Exhibit A: 02/05/16: Tier 1 Project Revisions

CANDLESTICK POINT
Proposed Project Revisions Associated with Development Plan Application for Sub-Phase 02-03-03 and Updates to Project Documents, Including:
CP Major Phase 1 Application, CP Design for Development (D4D),
CP Streetscape Master Plan, CP-HPS-Phase 2 MMRP, CP Transportation Plan

CANDLESTICK POINT
Tier 2 and Tier 3 Revisions Associated with Development Plan Application for Sub-Phase 02-03-03 and Updates to Project Documents, Including:
CP Major Phase 1 Application, CP Design for Development (D4D),
CP Streetscape Master Plan, CP-HPS-Phase 2 MMRP, CP Transportation Plan

Figure 5
Gilman Avenue

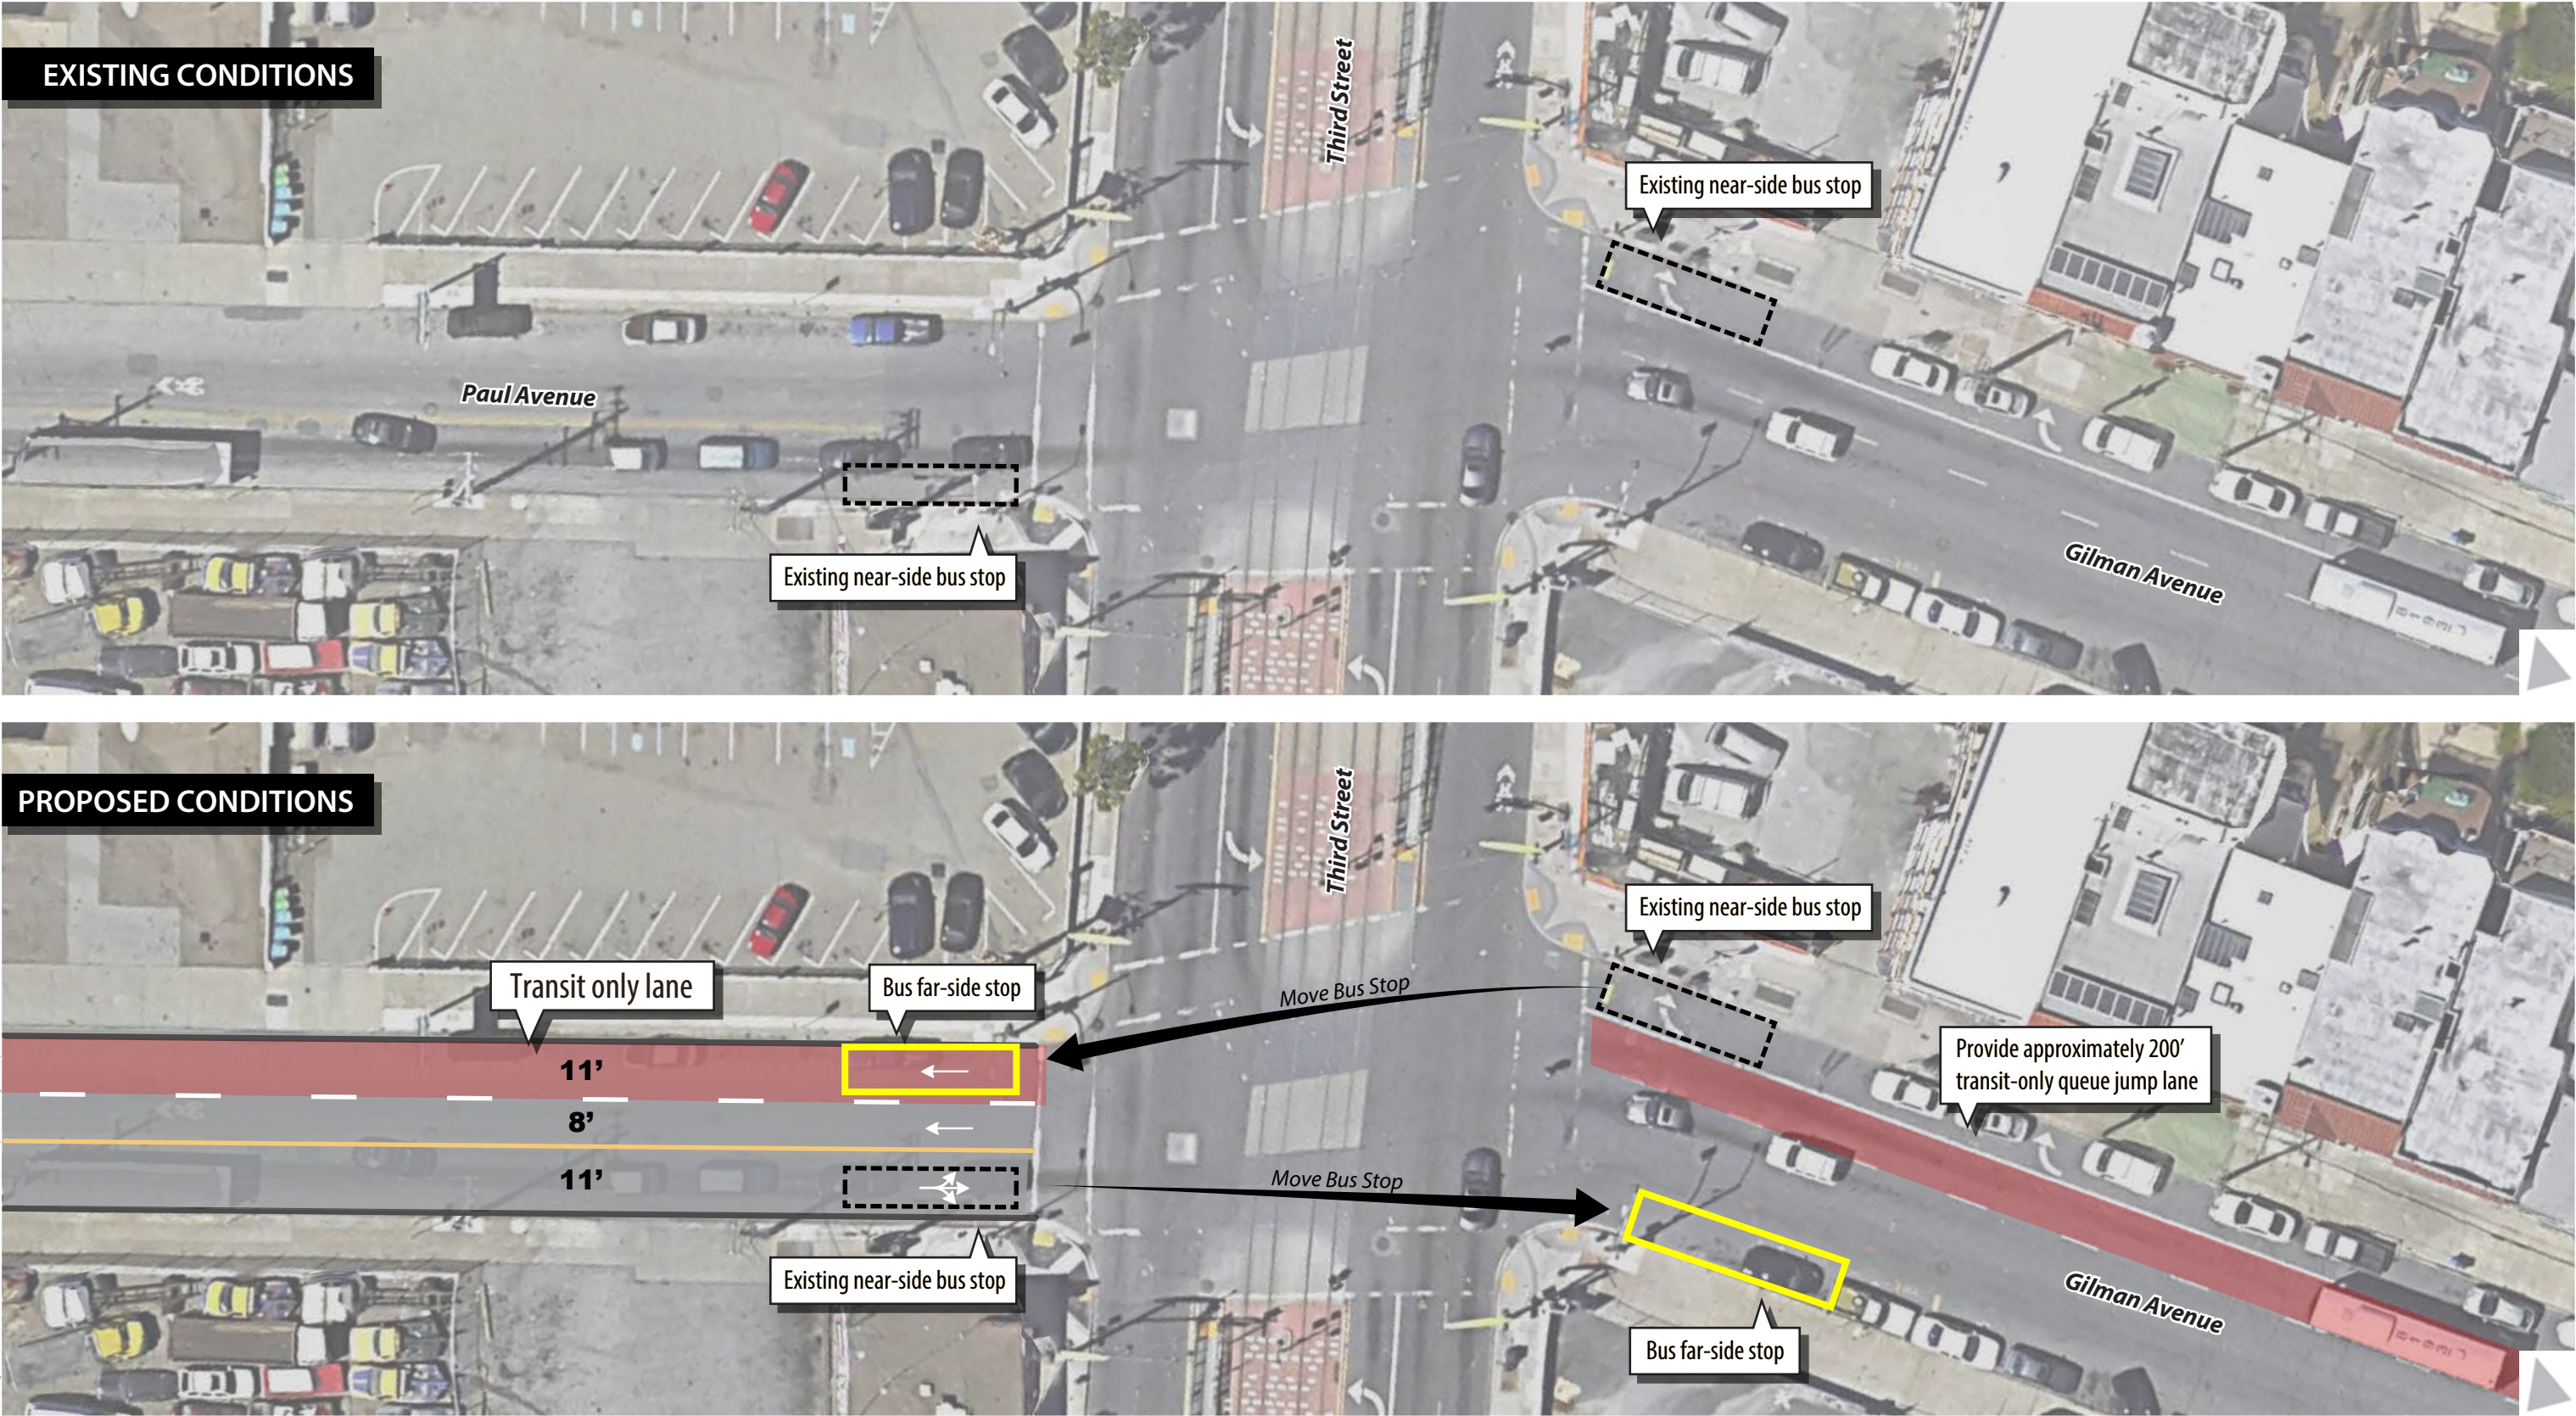
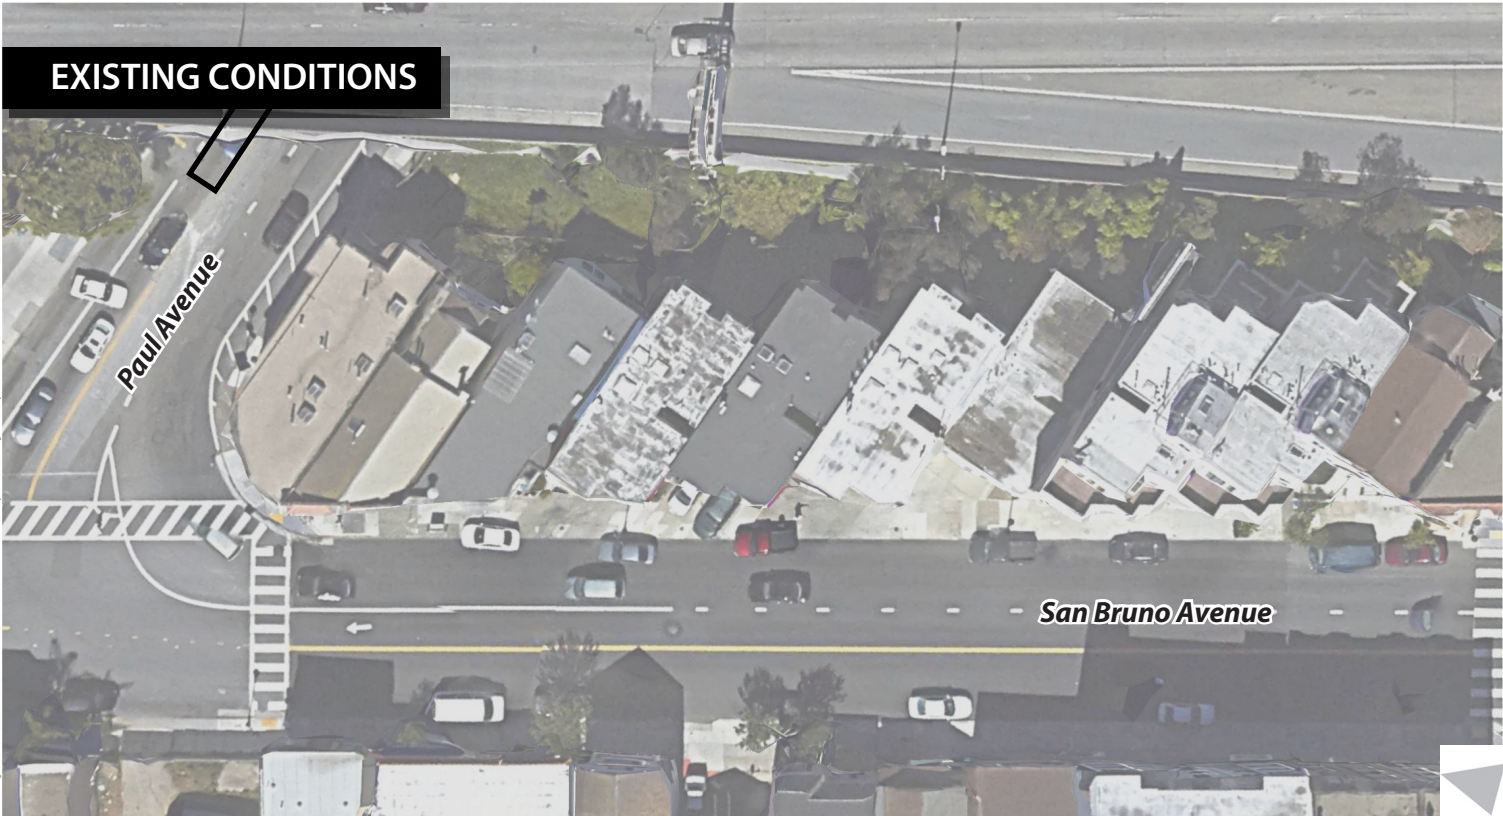
Figures 5 and 6 depict the revised mitigation measure along Route 29.

SHADOW STUDY: DECEMBER 21 - 10AM

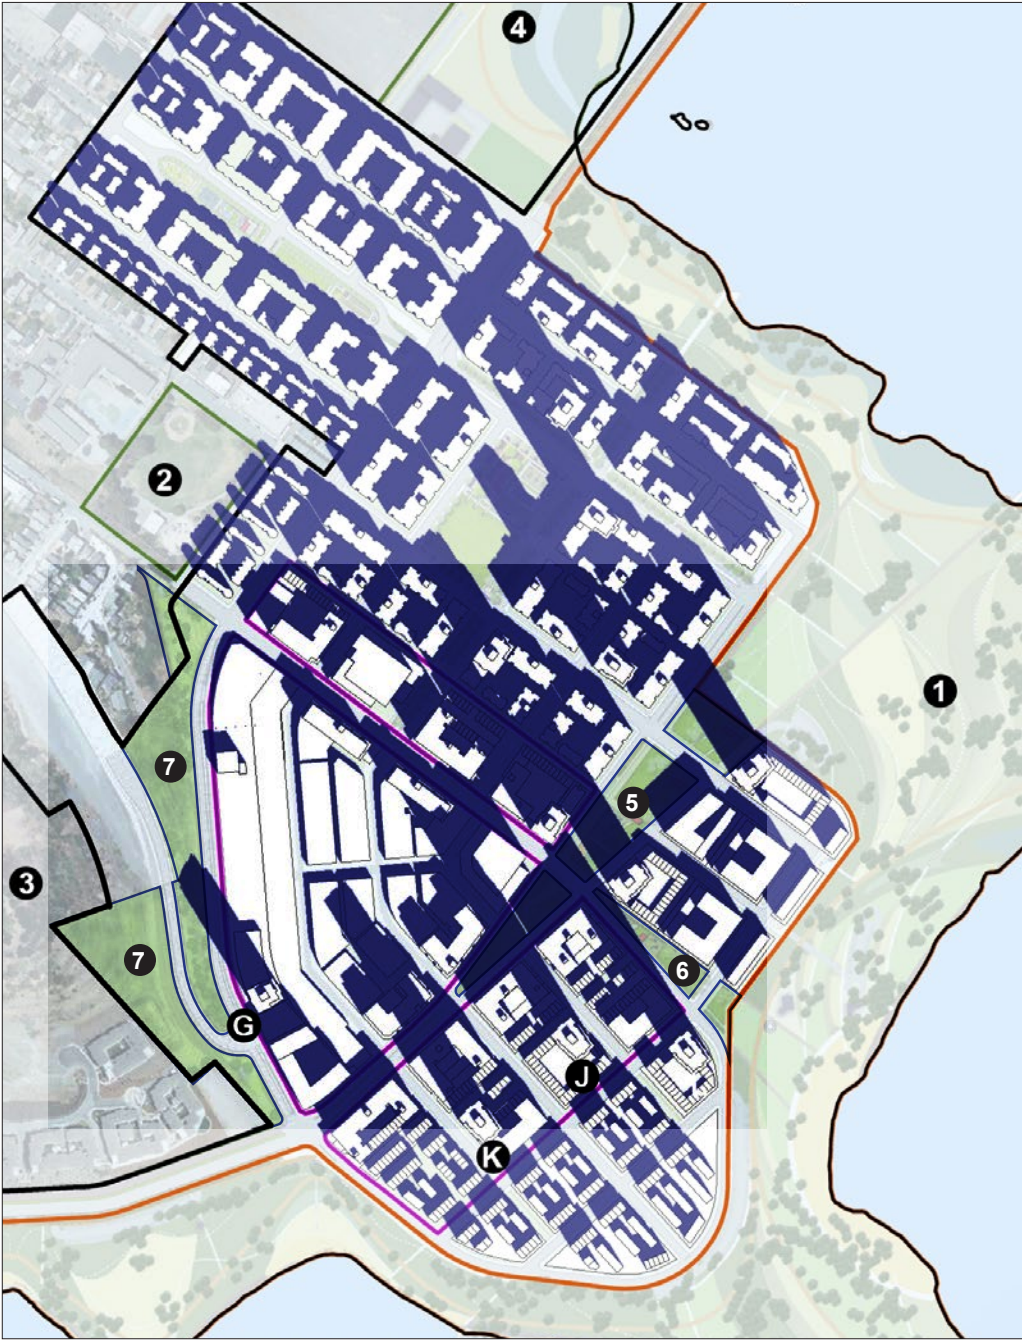
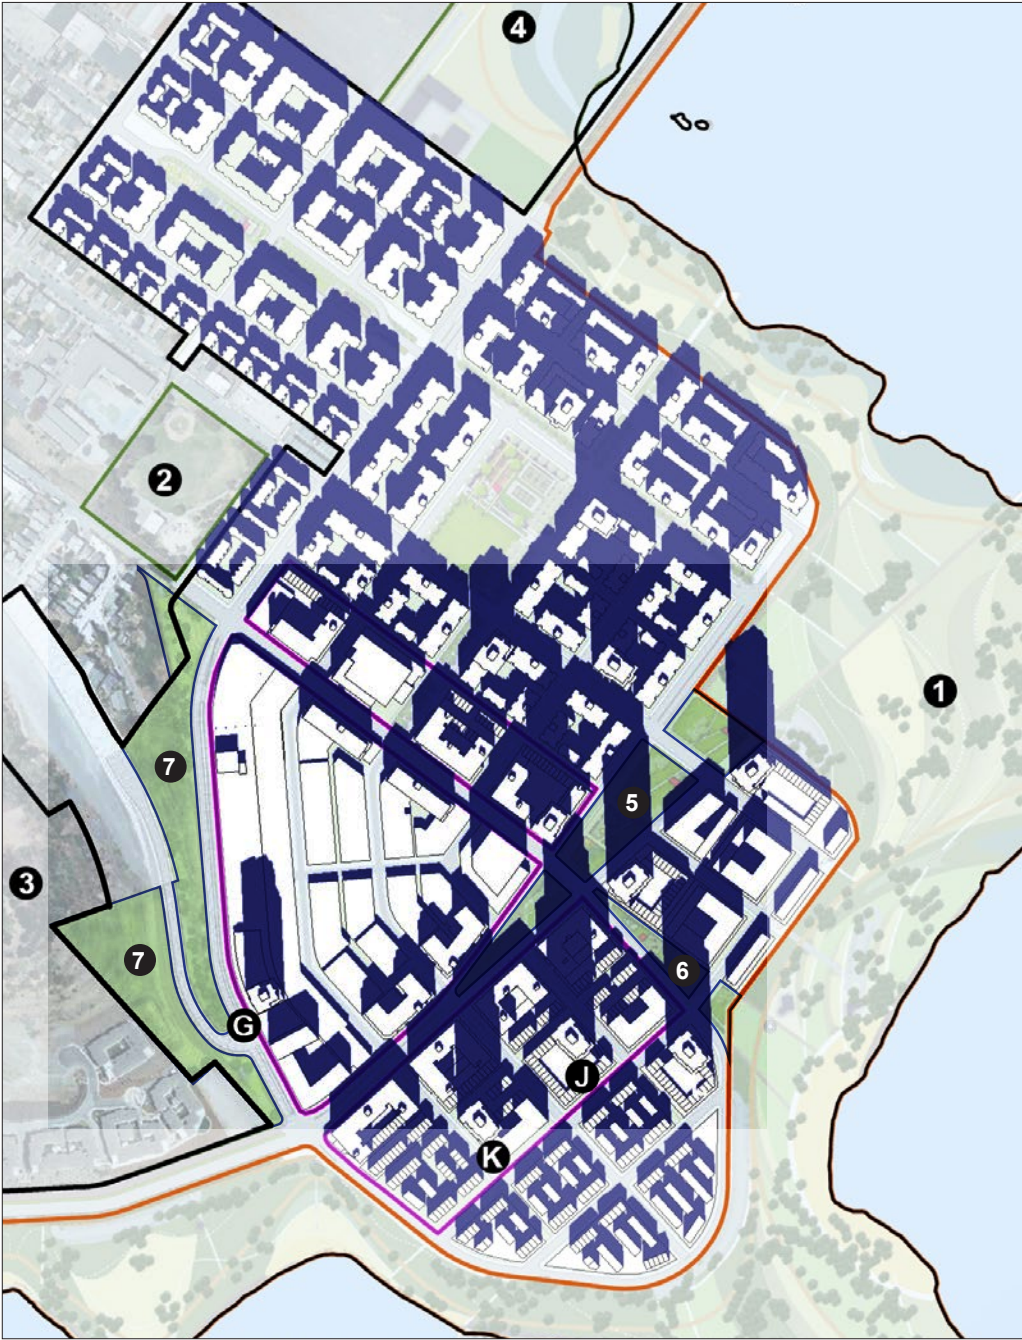
Proposed Revision	Existing Provision	Project Document(s) Revision
TIER 1: Substantive Project Revisions		
1. <u>Tower Relocation</u> : The sub-phase application proposes relocating Towers G, J and K. Tower G would be relocated within CP-02, but outside the approved tower zone. Tower J and K would be moved approximately 100 feet southeast. Tower K would remain in an approved tower zone and Tower K would be in a new fixed location.	D4D located Tower G in the approved tower location in the center of CP-02. D4D located Towers J and K in CP-South, approximately 100 feet north of the proposed location.	Major Phase 1 Application <ul style="list-style-type: none">• Section 1.1• Figure 6.1• Figure 6.5• Figure 6.6• Figure 6.7• Figure 6.8 D4D: <ul style="list-style-type: none">• Table 4.3• Figure 4.3• Figure 8.1
